**EPA Superfund
Record of Decision Amendment:**

**AMERICAN CREOSOTE WORKS, INC. (PENSACOLA
PLANT)**

**AMENDED
RECORD OF DECISION
OPERABLE UNIT 1**

**AMENDED
RECORD OF DECISION
OPERABLE UNIT 1
AMERICAN CREOSOTE WORKS**

Figure 5. Typical Cross Section of Low-Profile Surface Cap

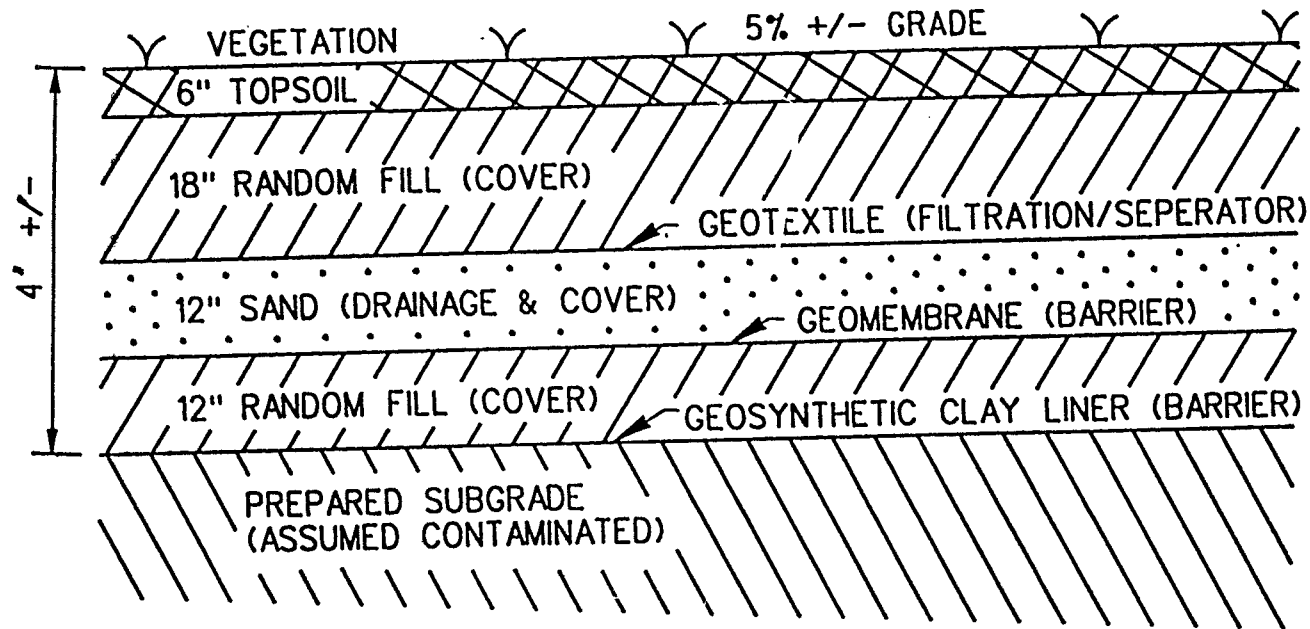
Comment: A commenter asked about the details of cap construction, including specifics about the barrier cloth, lines, and depth of clay. How will the cap be maintained, and what will be done to prevent roots from disrupting the cap? The commenter felt that a slurry wall or perimeter barrier must be constructed to prevent superficial ground water from flowing through highly contaminated areas of the Site.

Response: Cap construction details are presented in Section 10.1 of this AROD, and a cross-section showing the layers of the cap is provided in Figure 5. As part of the operation and maintenance (O&M) plan for the Site, the cap and the entire ACW property will be mowed as necessary during the growing season, which should prevent the growth of deep rooted plants. However, periodic inspections of the cap will be conducted following construction to evaluate the condition of the cap and drainage features, and a maintenance program will be implemented to prevent growth of trees or other deep-rooted vegetation from penetrating the barriers and to fill in any erosion that may occur. Future use of the Site will be limited to uses that do not require significant ground penetrations. Holes for poles, borings, trenches and other excavations deeper than 6 inches will not
